### LAVALLEE BRENSINGER ARCHITECTS

### **Field Report**

The Park Danforth			Project No:	13-059-00
Portland	ME		Field Report No	o: 23
То:	Mark Donovan PC Construction 131 Presumpscot Street Portland	ME	2 4.0 01 11010	8:30 AM 11/8/2016 Sunny, Clear (40F-60F)

See note 23.02.

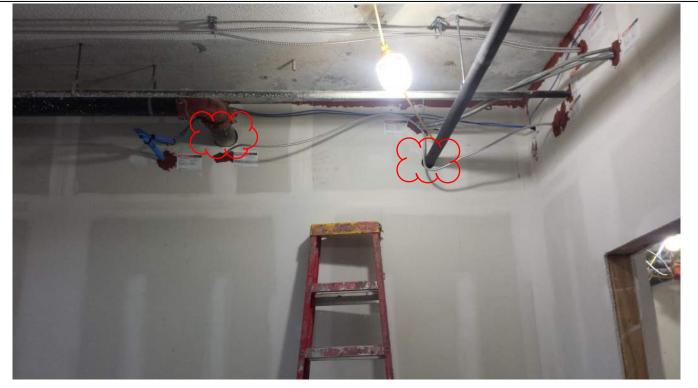
Item	Description	Status:
	<ul><li>MEP Rough ins ongoing in Main Street</li><li>Floor leveller application at Pub and Bistro underway</li></ul>	
23.02	In the Wellness Center 126, AC ceiling casettes should be mounted in the ACT ceiling, not the drywall cloud. See image A P 12 of 17	CM follow up

See note 23.04. Connector Corridor 141 shown

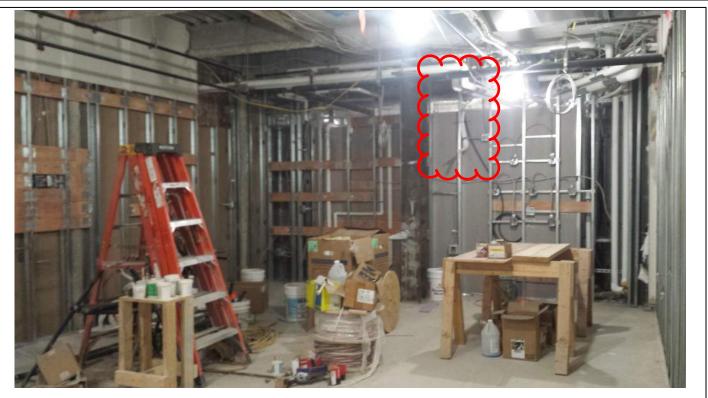
23.03	Wall pentrations between the Beauty Salon and the Stair tower should be consistently tagged and sealed. See image B P12 of 17.	Correct Work
23.04	Firespray underside of roof deck in connector and untreated columns. See Images A and B P13 of 17.	Correct Work

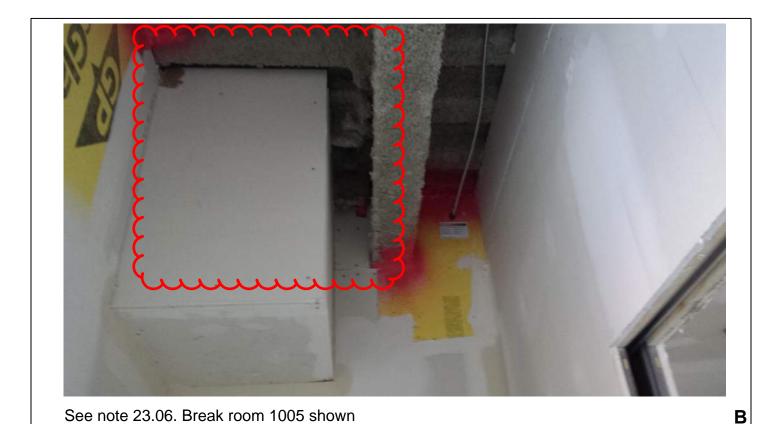
23.05	Relocate supply line for A/C unit in Media Room. Current location will interfere with light artfixtures on wall. Reference RFI 286 See image A P14 of 17	Correct Work
